Inspection Report for North Sturbridge Road Solar Facility

NPDES ID No.: MAR10031G

Inspection Date: 10/18/2021

FIGURE 1: SWPPP INSPECTION SKETCH 10/18/2021

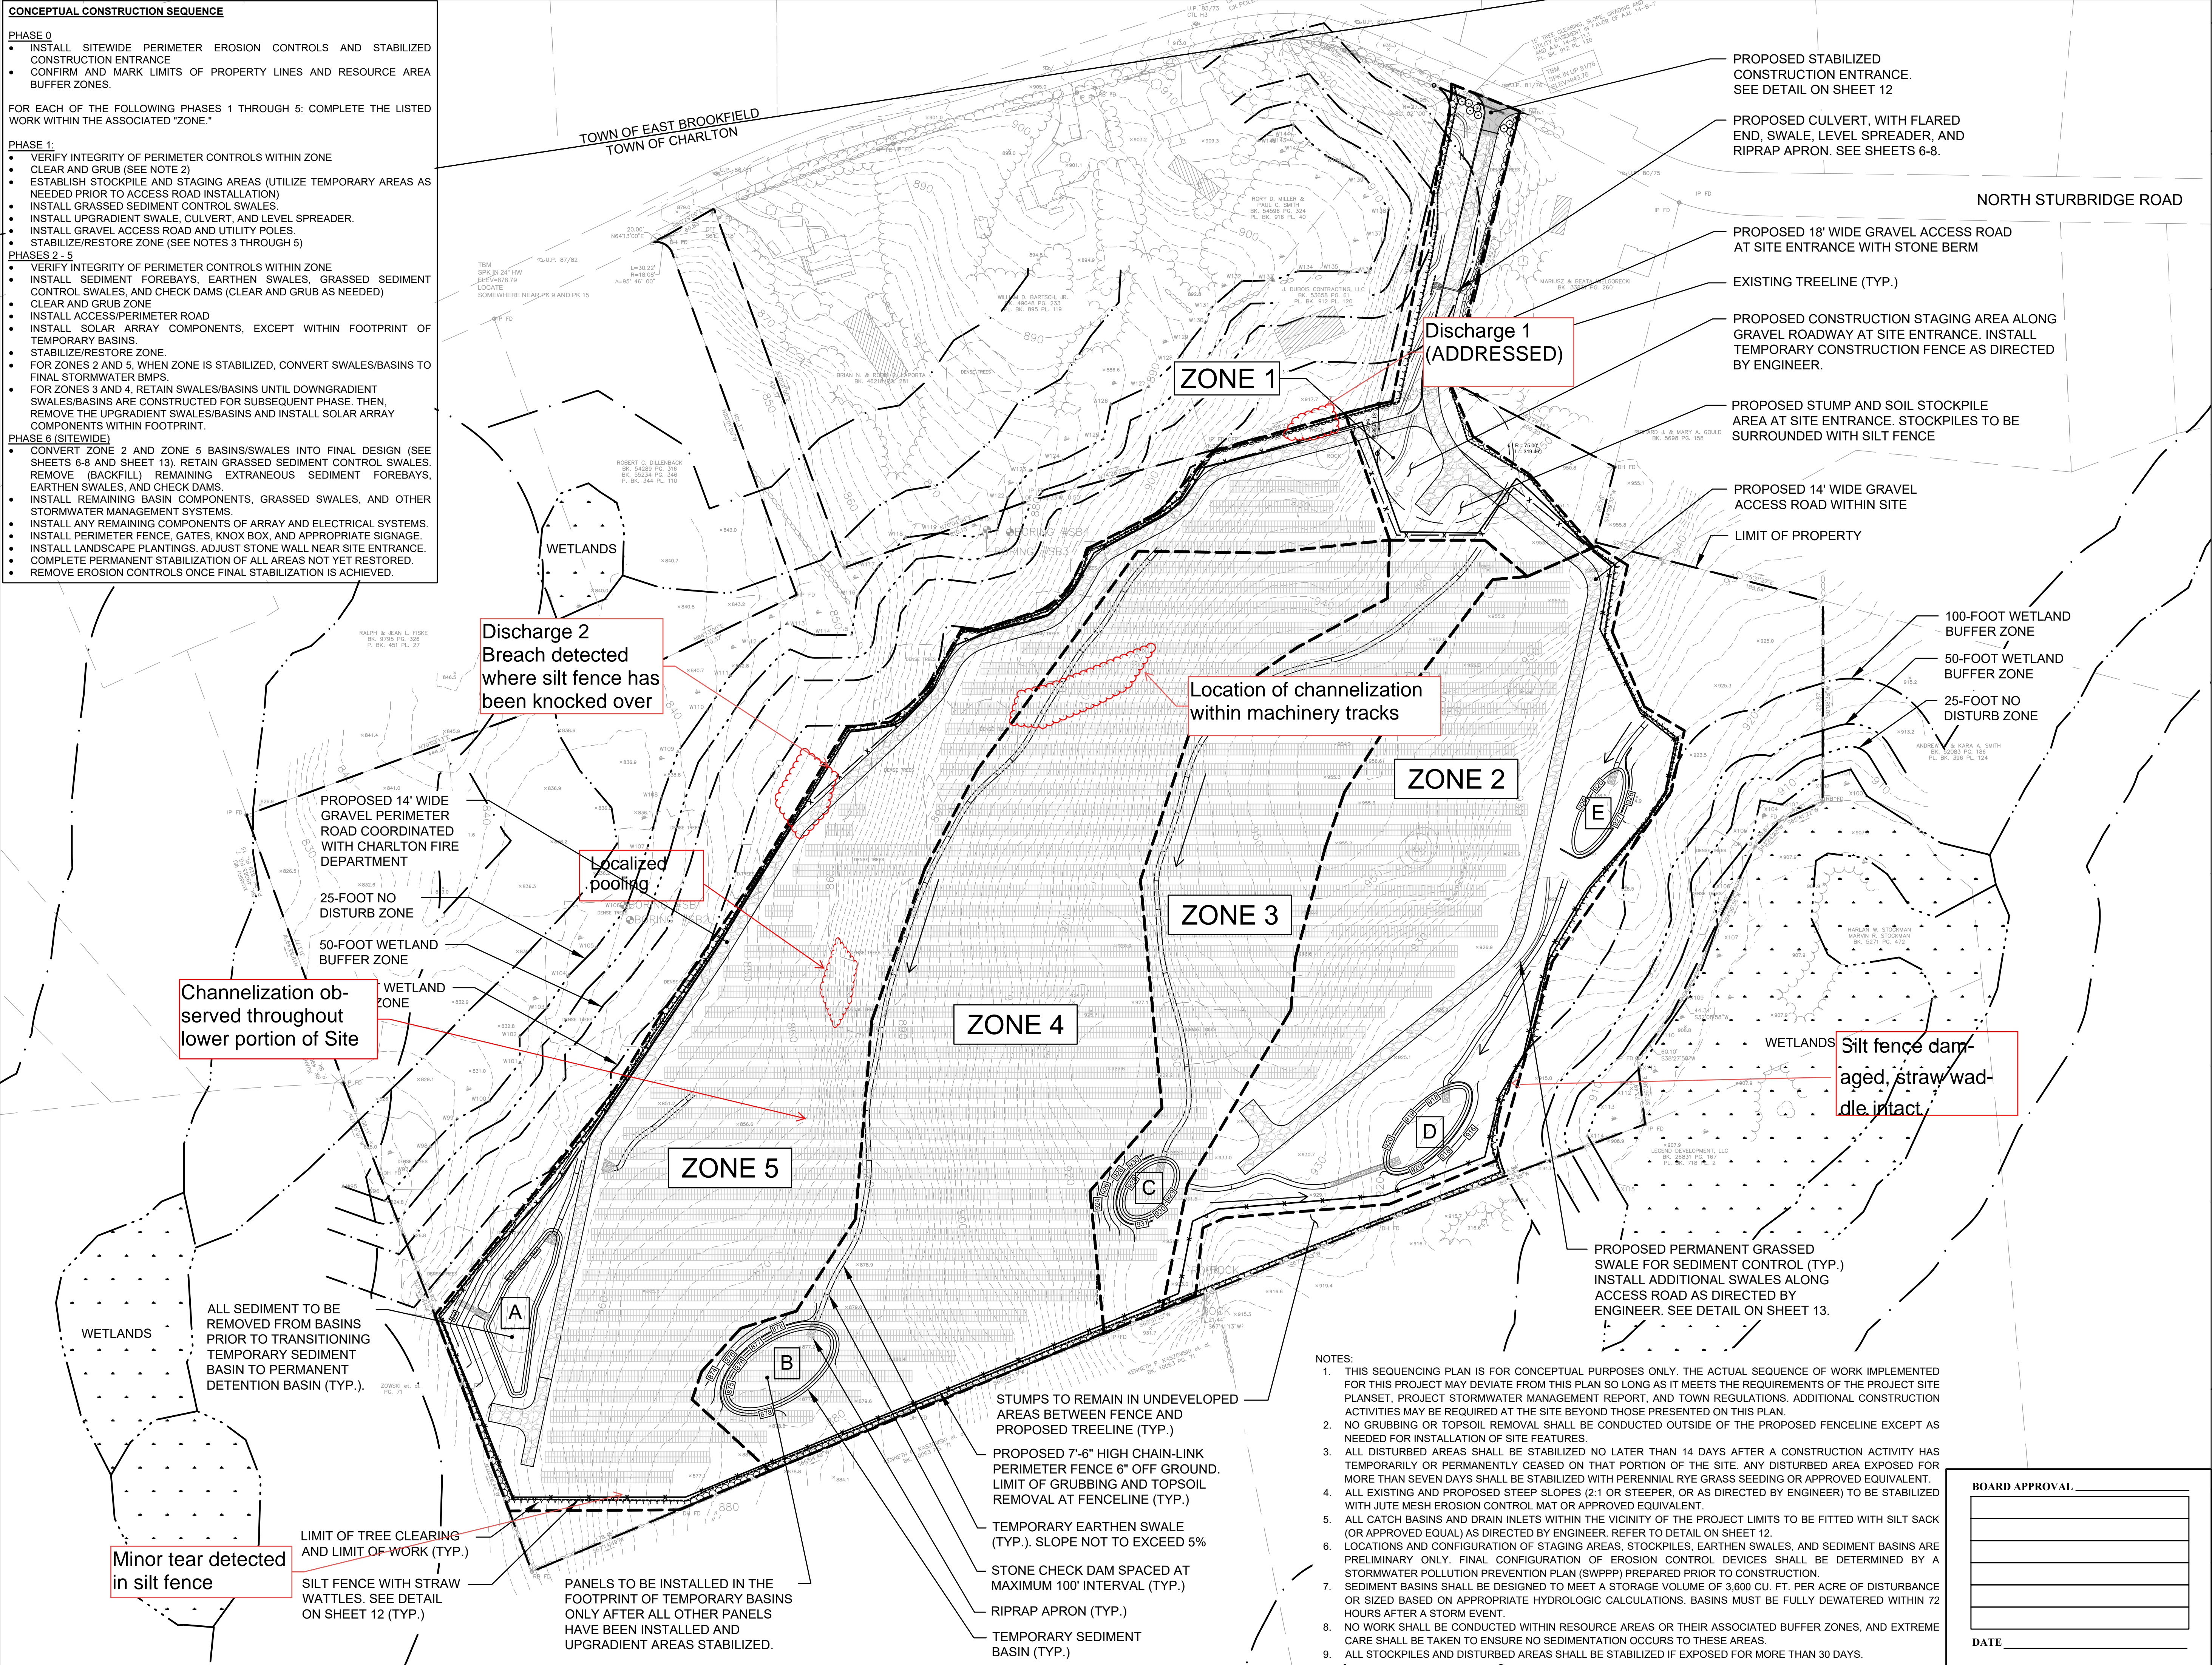
2. Informal access road along northern portion of the Site	Straw mulch or hydroseed	<input type="checkbox"/> Yes [Enter date] <input checked="" type="checkbox"/> No	Erosion channels are beginning to form within upgradient portions of the informal access road (Figure 1). The contractor indicated that stabilization by smoothing out soils and seeding or spreading mulch would occur on 7/30/2021. Stabilization of this area has not been initiated. After inspection of the area on 8/24/2021, it was determined that

Silt fence damaged, straw wad-dle intact

Minor tear detected in silt fence

Channelization observed throughout lower portion of Site

Localized pooling

Location of channelization within machinery tracks

Discharge 2 Breach detected where silt fence has been knocked over

Discharge 1 (ADDRESSSED)
